2210 E CHERRY ST | SEATTLE, WA 98122

SDCI No: 3037185-LU

DESIGN RECOMMENDATIONS | MAY 12, 2022

ACCION HOUSE

diagram 1.a.1: setbacks at north property line

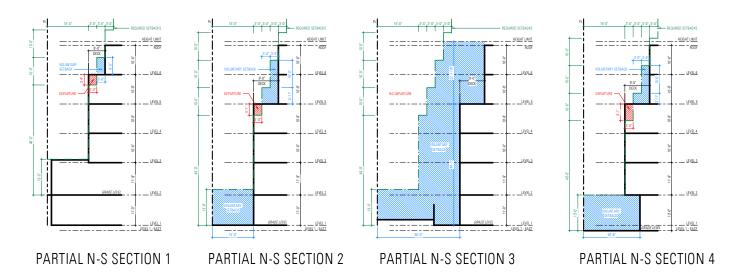
Echoing public comment, the Board supported the C-shaped massing, street-facing courtyard, and the stepping of the overall mass proposed in massing Concept 3. There was, however, concern that with the added height of the proposed rezone on a zone edge exacerbated the height drop of the adjacent zone, and that the height, bulk, and scale of the building did not adequately address the zone transition to the north and west of the site. The Board strongly recommended that the applicant further develop the massing to include appropriate top-level setbacks to help alleviate the perceived height of the building and allow more opportunity for daylight into neighboring properties.

The proposed building design has been developed further so that the impact of the massing is mitigated to the north and west of the site.

As seen in the diagrams to the right, the building sets back on the north side. At the eastern ¾ of the northern façade, Level 1 sets back 15 ft (which is 15 ft more than required by the Land Use Code) and Levels 5 and 6 set back 24 ft (which is 3 ft more than is required at Level 5). At the western ¼ of the northern façade, Level 6 sets back 21 ft. The proposal requests a partial-level departure from the required additional 3 ft set back above 40 ft height at the top of Level 4 for the eastern portion and at the top of Level 5 for the western portion. These one-step large upper-level setbacks were chosen because they still define a cohesive massing volume and avoid a "tiered-level layer cake" aesthetic that does not fit in with the project's design narrative, nor does it allow for efficient and sustainably constructed and laid-out stacking unit interiors. The introduction of these north upper-level setbacks allows for more daylight into the neighboring buildings, and the partial-level departure is only being requested at the Level 4 and 5 where it will have no affect on shadows cast to the north.

At the western façade, the project team has set back Level 2 (at 22nd Ave street-level) and Level 6 by 1 ft (which is 1 ft more than required by the Land Use Code). Levels 1 and 6 define the background massing that anchors the building to the ground, and they receive a more muted dark bronze fiber cement panel color and material palette. The protruding Levels 3-5 read as a horizontal band that gets further definition and depth from its faceted horizontal metal cladding in a rich copper tone. Levels 3-5 are further accentuated by hosting three stacks of accessorizing bright yellow balconies. The architectural massing, the material and color choices, and the accessorizing all draw the attention to Levels 3-5, and the massing of Level 6 s intentionally reduced and de-emphasized.

diagram 1.b.1 - north south site section - at 22nd ave

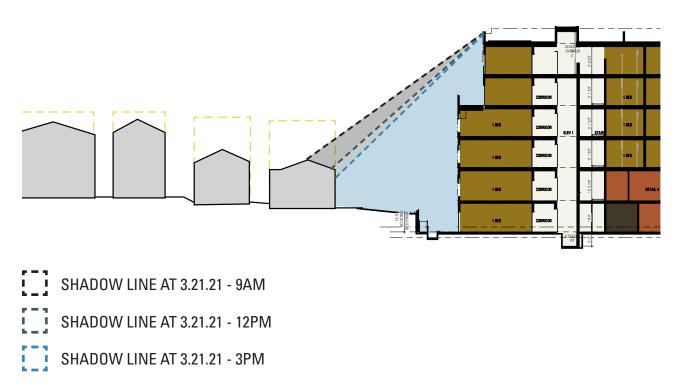
At the next stage, the Board requested site sections that clearly illustrate the heights of the adjacent properties and the proposed massing in both the east/west and north/south directions and enlarged sections along the north property line showing the shade and shadow effects of the design on the backyards of the adjacent homes.

Site sections are located in the "Sections" portion of the packet. See below for enlarged section at the north property line. Refer to "Shadow Studies" section of the packet for additional sun/shade diagrams.

diagram 1.c.1: perspective view from 23rd ave looking North with adjacent properties' zoning envelopes

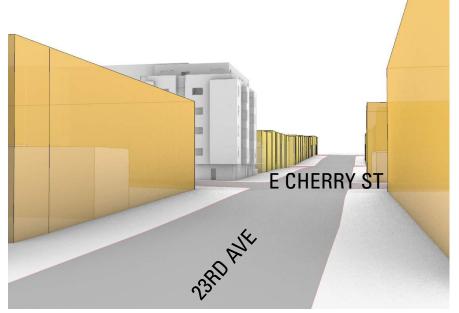
There was concern by the Board with the lack of modulation and upper-level setback in the mass at the corner of E Cherry St and 23rd Ave. Specifically referencing the Central Area Design Guideline A.1.3.a, the Board gave guidance to study ways in which the design could respond to the lower scaled, existing fabric to the east. Moving forward, the Board recommended more thorough study of this corner as it is viewed from all directions, with more attention given to the approach coming from the east.

The guidance in the neighborhood guideline referenced, A.1.3.a.1, was for "Smaller-scaled fabric with many culturally specific restaurants, as well as community and youth-centered resources", not for lower-scaled buildings. As authors of the Central Area Neighborhood Design Guidelines (CANDG), design team members Donald King and Grace Kim know this was intended to address community desire to retain small, locally-owned, culturally-relevant businesses, not to lower density. The proposed retail design includes commercial spaces of less than 1000sf to accommodate the smaller-scale fabric that we are trying to retain with these existing and new neighborhood businesses.

The corner of E Cherry St and 23rd Ave now has upper-level setbacks. On E Cherry St, Level 6 of the east wing sets back 12 ft, which creates a south-facing shared amenity deck with views of the mountains to the east. On 23rd Ave, Level 6 sets back 4 ft, which creates small private unit decks.

The east wing background mass is defined by a warm cream fiber cement panel cladding. To modulate the mass, the design team has introduced protruding bays, juliette balconies, and an overhead canopy at the street-level. The vertical bays are clad in horizontal metal with two alternating colors that take inspiration from the African Kente stole. The juliette balconies are bright yellow accessories that allow residents to open their units to the outdoors. The overhead canopy at the street-level creates a more intimate, pedestrian-scaled sidewalk experience that relates to the existing street-level uses across 23rd Ave.

diagram 2.c.1: option 1 section study of the courtyard

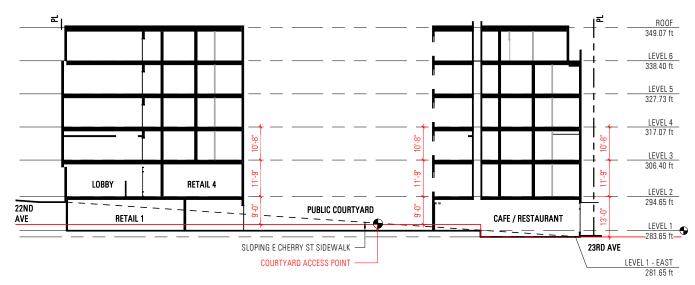
The Board requested that the applicant show studies for raising the courtyard level to allow for more direct access from the sidewalk, increasing the connectivity to the courtyard with added stairs, or by other means to encourage a more porous edge along E Cherry St.

In response to the Board's guidance, the design team studied options for further raising the Courtyard level:

Option 1: To raise the Courtyard and the adjacent commercial spaces, the design team would need to further decrease the floor-to-floor height of Level 1 to about 9 ft. This is not a desirable ceiling height for retail.
